Project	<b>IEEE 802.16 Broadband Wireless Access Working Group</b> < <a href="http://ieee802.org/16">http://ieee802.org/16</a> >	
Title	<b>Structure and notation enhancements to IEEE P802.16h/D3</b>	
Date Submitted	<b>2007-11-03</b>	
Source(s)	Paul Piggin NextWave Broadband Inc. 12670 High Bluff Drive San Diego CA 92130 USA	Voice: 1 858 480 3100 Fax: 1 858 480 3105 ppiggin @ nextwave.com
Re:	Letter Ballot #29 of IEEE P802.16h/D3.	
Abstract	There are a number of structural and notional enhancements that should be applied to the IEEE P802.16h/D3 draft.	
Purpose	Ensuring the readability of the draft IEEE P802.16h/D3.	
Notice	<i>This document does not represent the agreed views of the IEEE 802.16 Working Group or any of its subgroups. It represents only the views of the participants listed in the "Source(s)" field above. It is offered as a basis for discussion. It is not binding on the contributor(s), who reserve(s) the right to add, amend or withdraw material contained herein.</i>

# Structure and notation enhancements to IEEE P802.16h/D3

Replace Figure h19 in [1] ‘Reclaiming the Medium’ with the follow:

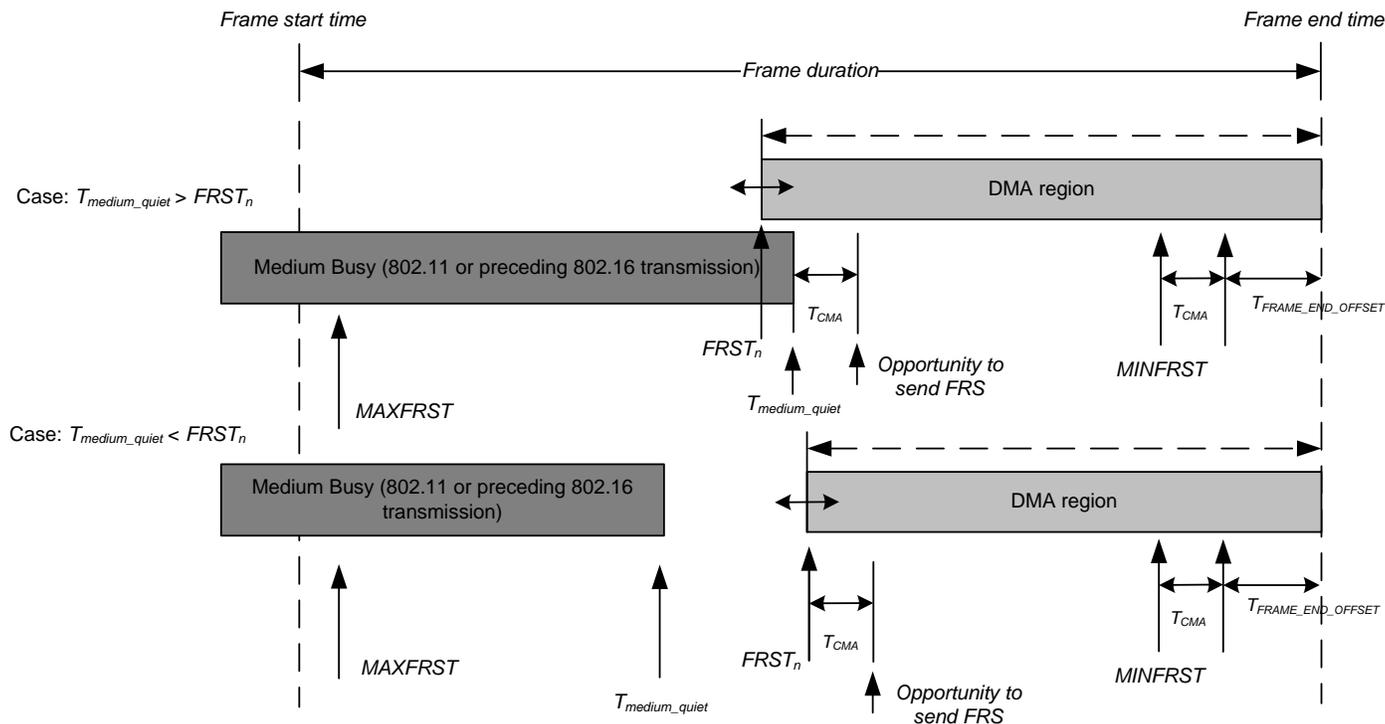
*Make the following changes to subclause 6.4.2.3.7 ‘Listen-Before-Talk (LBT)’, Page 41, line 58:*

*MAXFRST - the maximum value of FRST. Band dependent. ~~For example, in the 3.65 GHz band in the US 4 ms is a reasonable value since any 802.11 burst in this band would be shorter and could fit before the start of the 802.16 frame.~~*

$$MINFRST = T_{CMA} + T_{FRAME\_END\_OFFSET}$$

Figure h21 (a) Downlink FRS

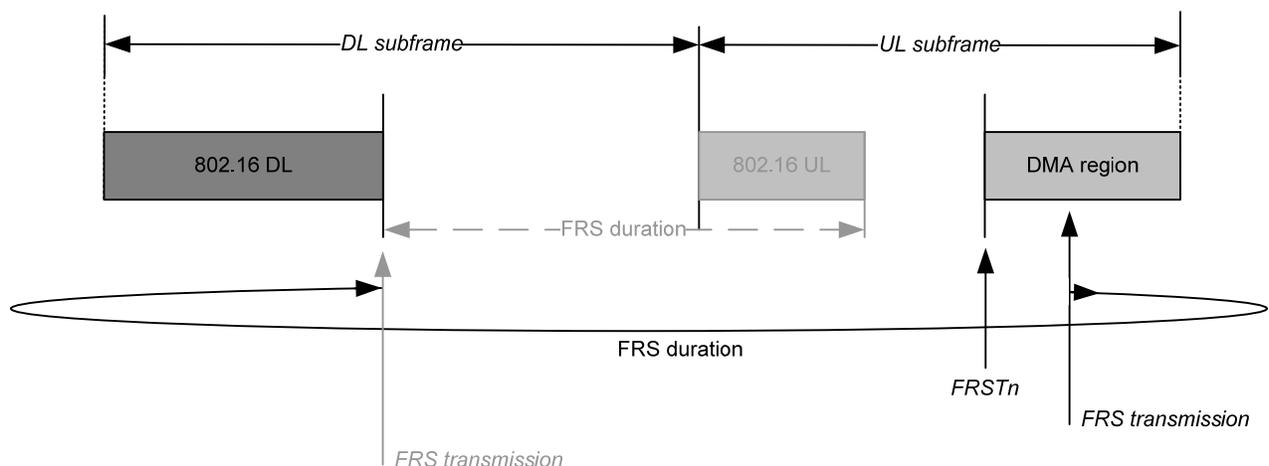
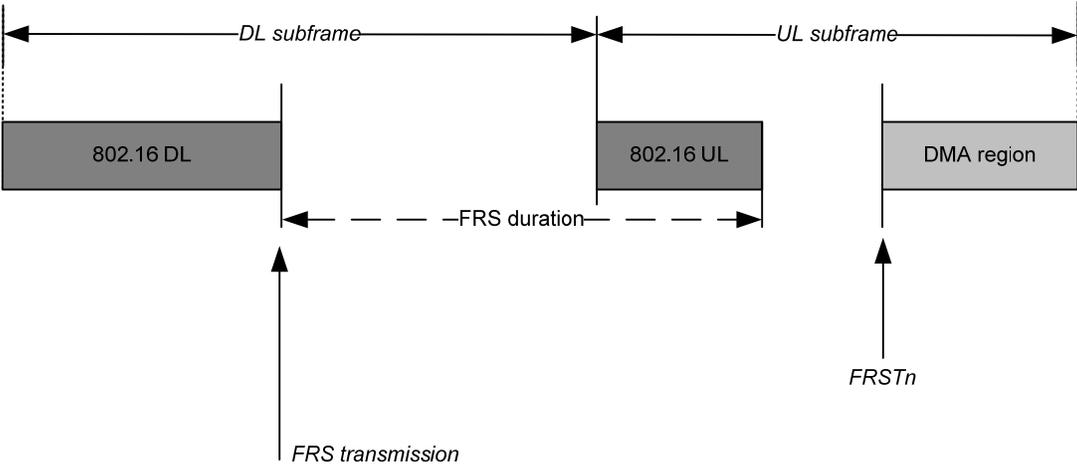
When using any carrier sense protocol, such as LBT, in a wireless environment the hidden node problem cannot be 100% avoided. It can only be mitigated. Additionally, in bands such as 3.65 GHz in the US, there is an aggravated hidden node problem due to the distinctly lower transmit power allowed for mobile devices compared to fixed, registered devices. The mobiles are more often geographically disadvantaged due to this transmit power disparity. Fixed, registered client devices can also be geographically disadvantaged (the classical hidden node problem), although not as often. To remedy this the BS transmits a Frame Reservation Signal (FRS) at the end of the DL subframe to reserve the subsequent UL subframe (or used portion, thereof) for the subscriber stations. [The BS also transmits an FRS in the DMA region at the time a decision is made to claim the medium.](#) The form of the FRS is band dependent and should be structured to be receivable by other technologies that may be co-channel. For instance, in bands where 802.11 would be a typical co-channel asynchronous system, the 802.11 CTS transmitted using the appropriate 802.11 burst structure would suffice. The reservation of the [DL and](#) UL subframe by the BTS precludes the need for the SS to also perform LBT. ~~The use of~~ [An example of using](#) the FRS to protect the [DL and](#) UL is shown in *Figure h 21*.

Replace figure h21 with the following.
